Subject: FW: WBLR phase 3 – A2300 drainage approach

Subject: RE: WBLR phase 3 – A2300 footway discharge rates

Re: WBLR phase 3 – A2300 footway discharge rates

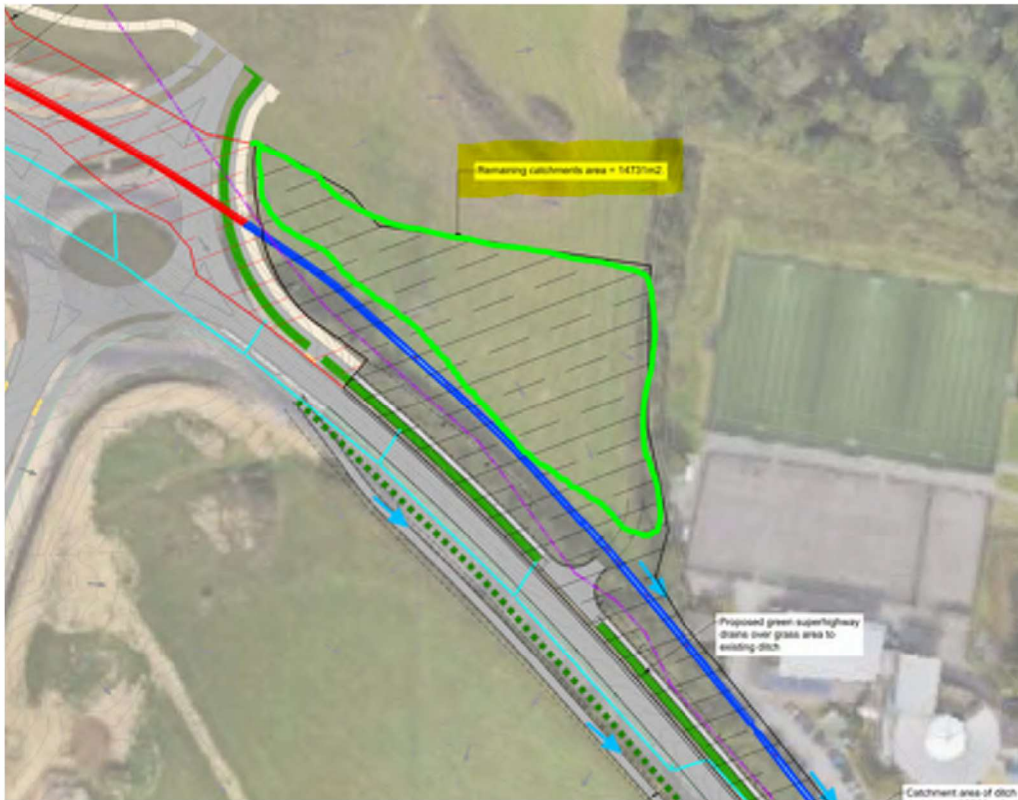
Also – another point regarding the flows into the existing ditch system that *might* have some bearing: The existing catchment includes an area of the adjacent field / development plot – approx. extent encircled in green below. When the plot is developed - a large portion of this area will then be drained to the north towards the River Adur and discharged at a controlled rate based on Qbar? We believe the plot development will not be allowed to discharge into the ditch at all - as it is a highway ditch in highway land? When this occurs – the flows in the ditch and then through the A2300 culvert will be further reduced such that they are then significantly lower than the greenfield / pre-development flows:

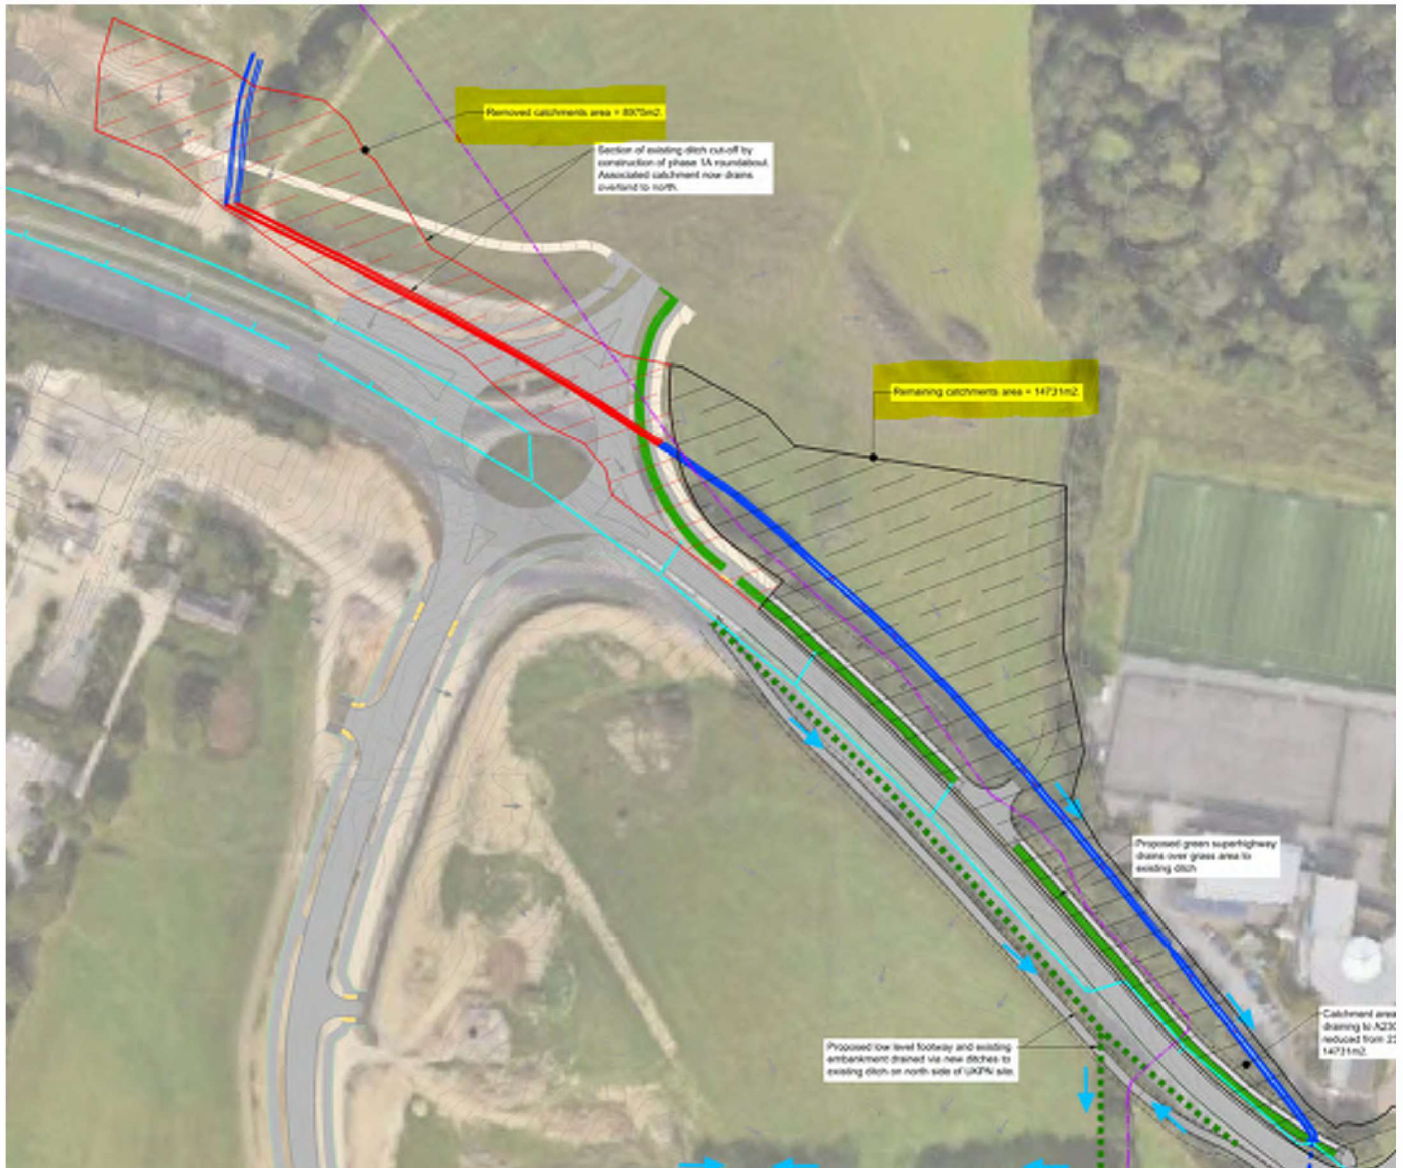
- The catchment area of the ditch on the north side of the A2300 has already been significantly reduced (from approx. 2.37ha down to 1.47ha) following the construction of the phase 1A roundabout, with an area now draining northward overland to the River Adur and an area now draining via the phase 1 highway drainage network to the phase 1 attenuation basins. This catchment reduction (approx. 0.9ha) equates to a reduced flow along the remaining ditch and through the culvert under the A2300, based on Q_{bar} , of $0.9ha \times 5.8l/s/ha = 5.22l/s$. This reduction is greater than the north side rate increase due to the proposed phase 3 footway in table above ($0.8l/s$ increasing to $4.7l/s = 3.9l/s$ increase), therefore overall - there is a reduction in flows at the A2300 culvert of approx. $3.9l/s - 5.22l/s = -1.32l/s$.

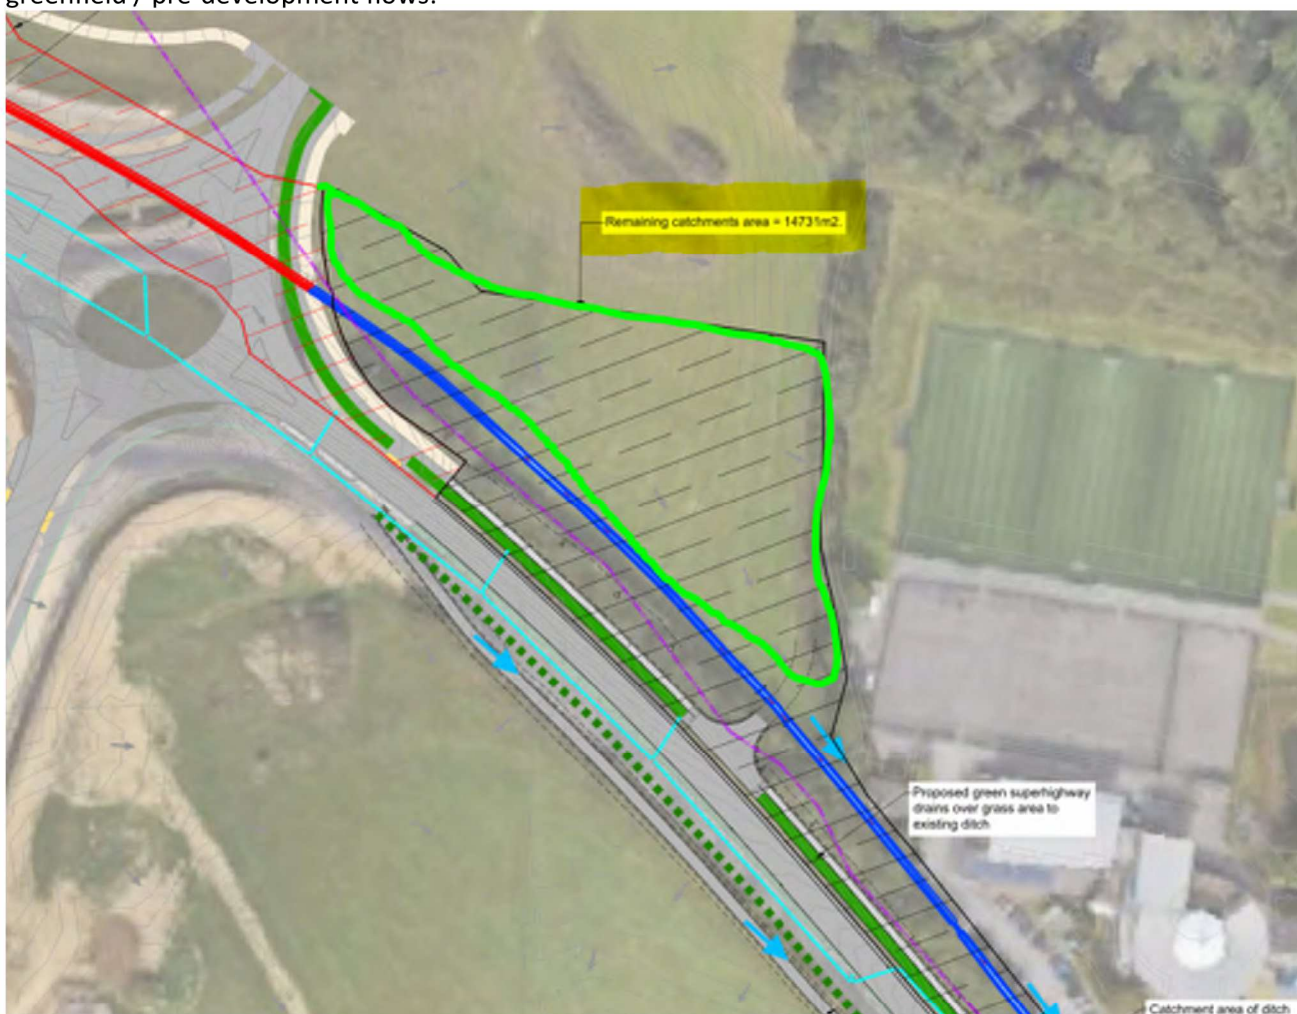
Also – another point regarding the flows into the existing ditch system that *might* have some bearing: The existing catchment includes an area of the adjacent field / development plot – approx. extent encircled in green below. When the plot is developed - a large portion of this area will then be drained to the north towards the River Adur and discharged at a controlled rate based on Qbar? We believe the plot development will not be allowed to discharge into the ditch at all - as it is a highway ditch in highway land? When this occurs – the flows in the ditch and then through the A2300 culvert will be further reduced such that they are then significantly lower than the greenfield / pre-development flows:

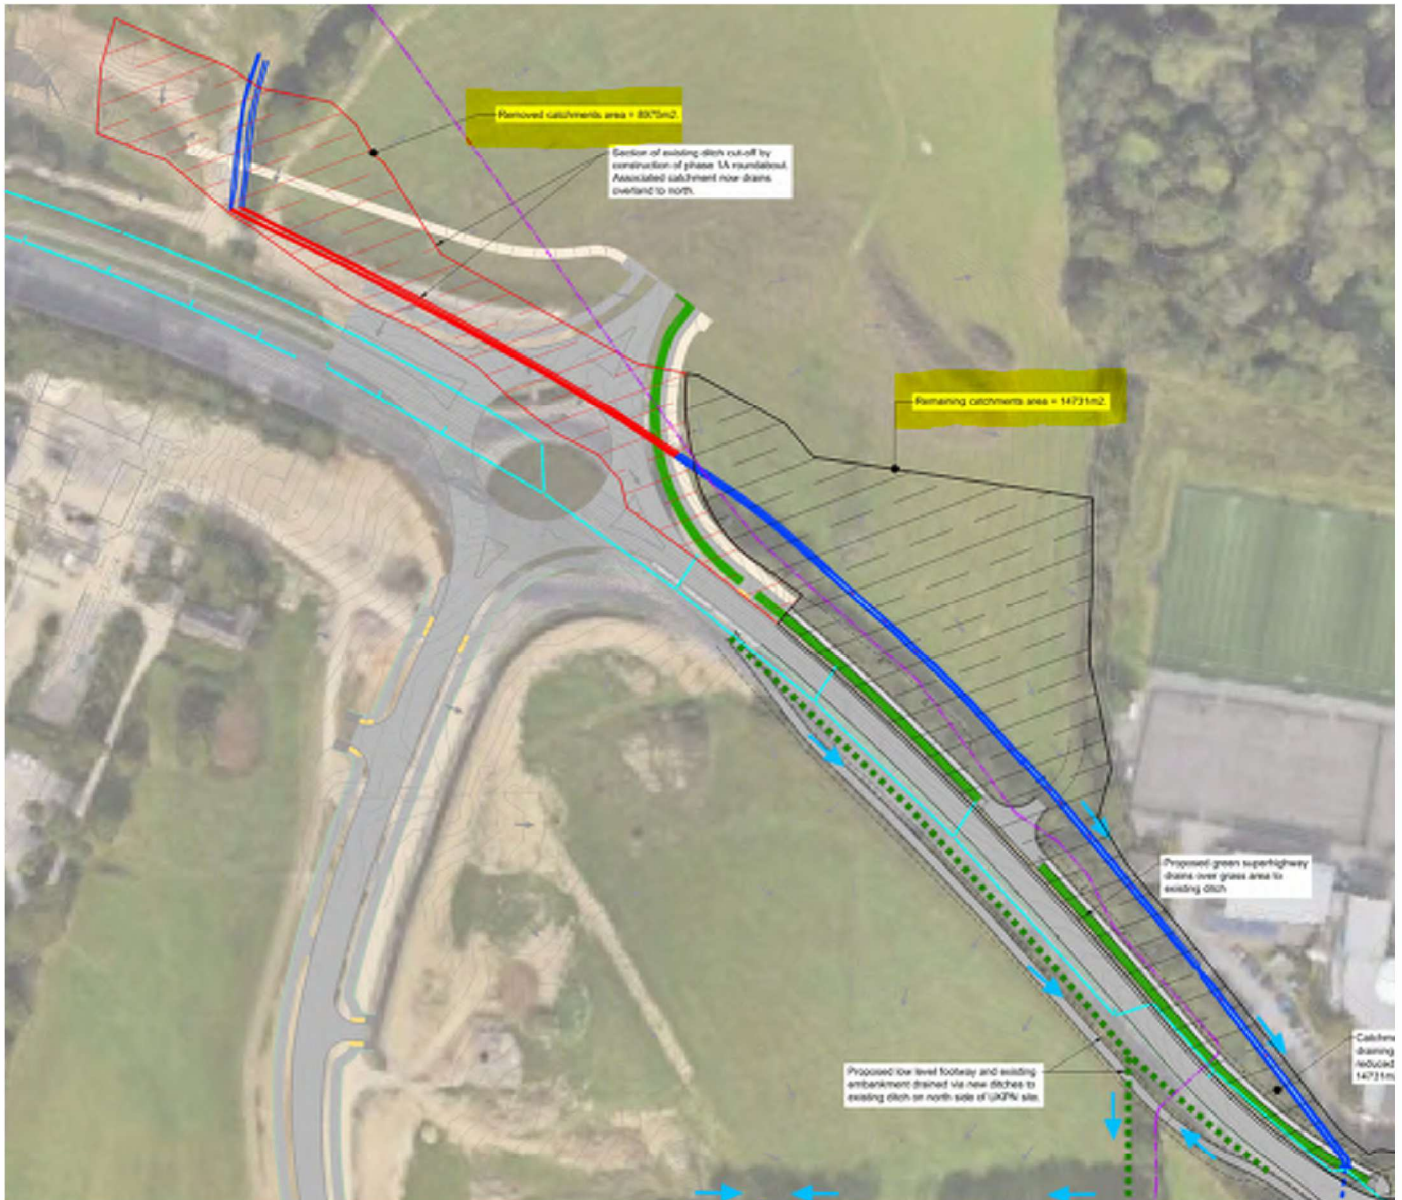
- The catchment area of the ditch on the north side of the A2300 has already been significantly reduced (from approx. 2.37ha down to 1.47ha) following the construction of the phase 1A roundabout, with an area now draining northward overland to the River Adur and an area now draining via the phase 1 highway drainage network to the phase 1 attenuation basins. This catchment reduction (approx. 0.9ha) equates to a reduced flow along the remaining ditch and through the culvert under the A2300, based on Qbar, of 0.9ha x 5.8l/s/ha = 5.22l/s. This reduction is greater than the north side rate increase due to the proposed phase 3 footway in table above (0.8l/s increasing to 4.7l/s = 3.9l/s increase), therefore overall - there is a reduction in flows at the A2300 culvert of approx. 3.9l/s-5.22l/s = -1.32l/s.
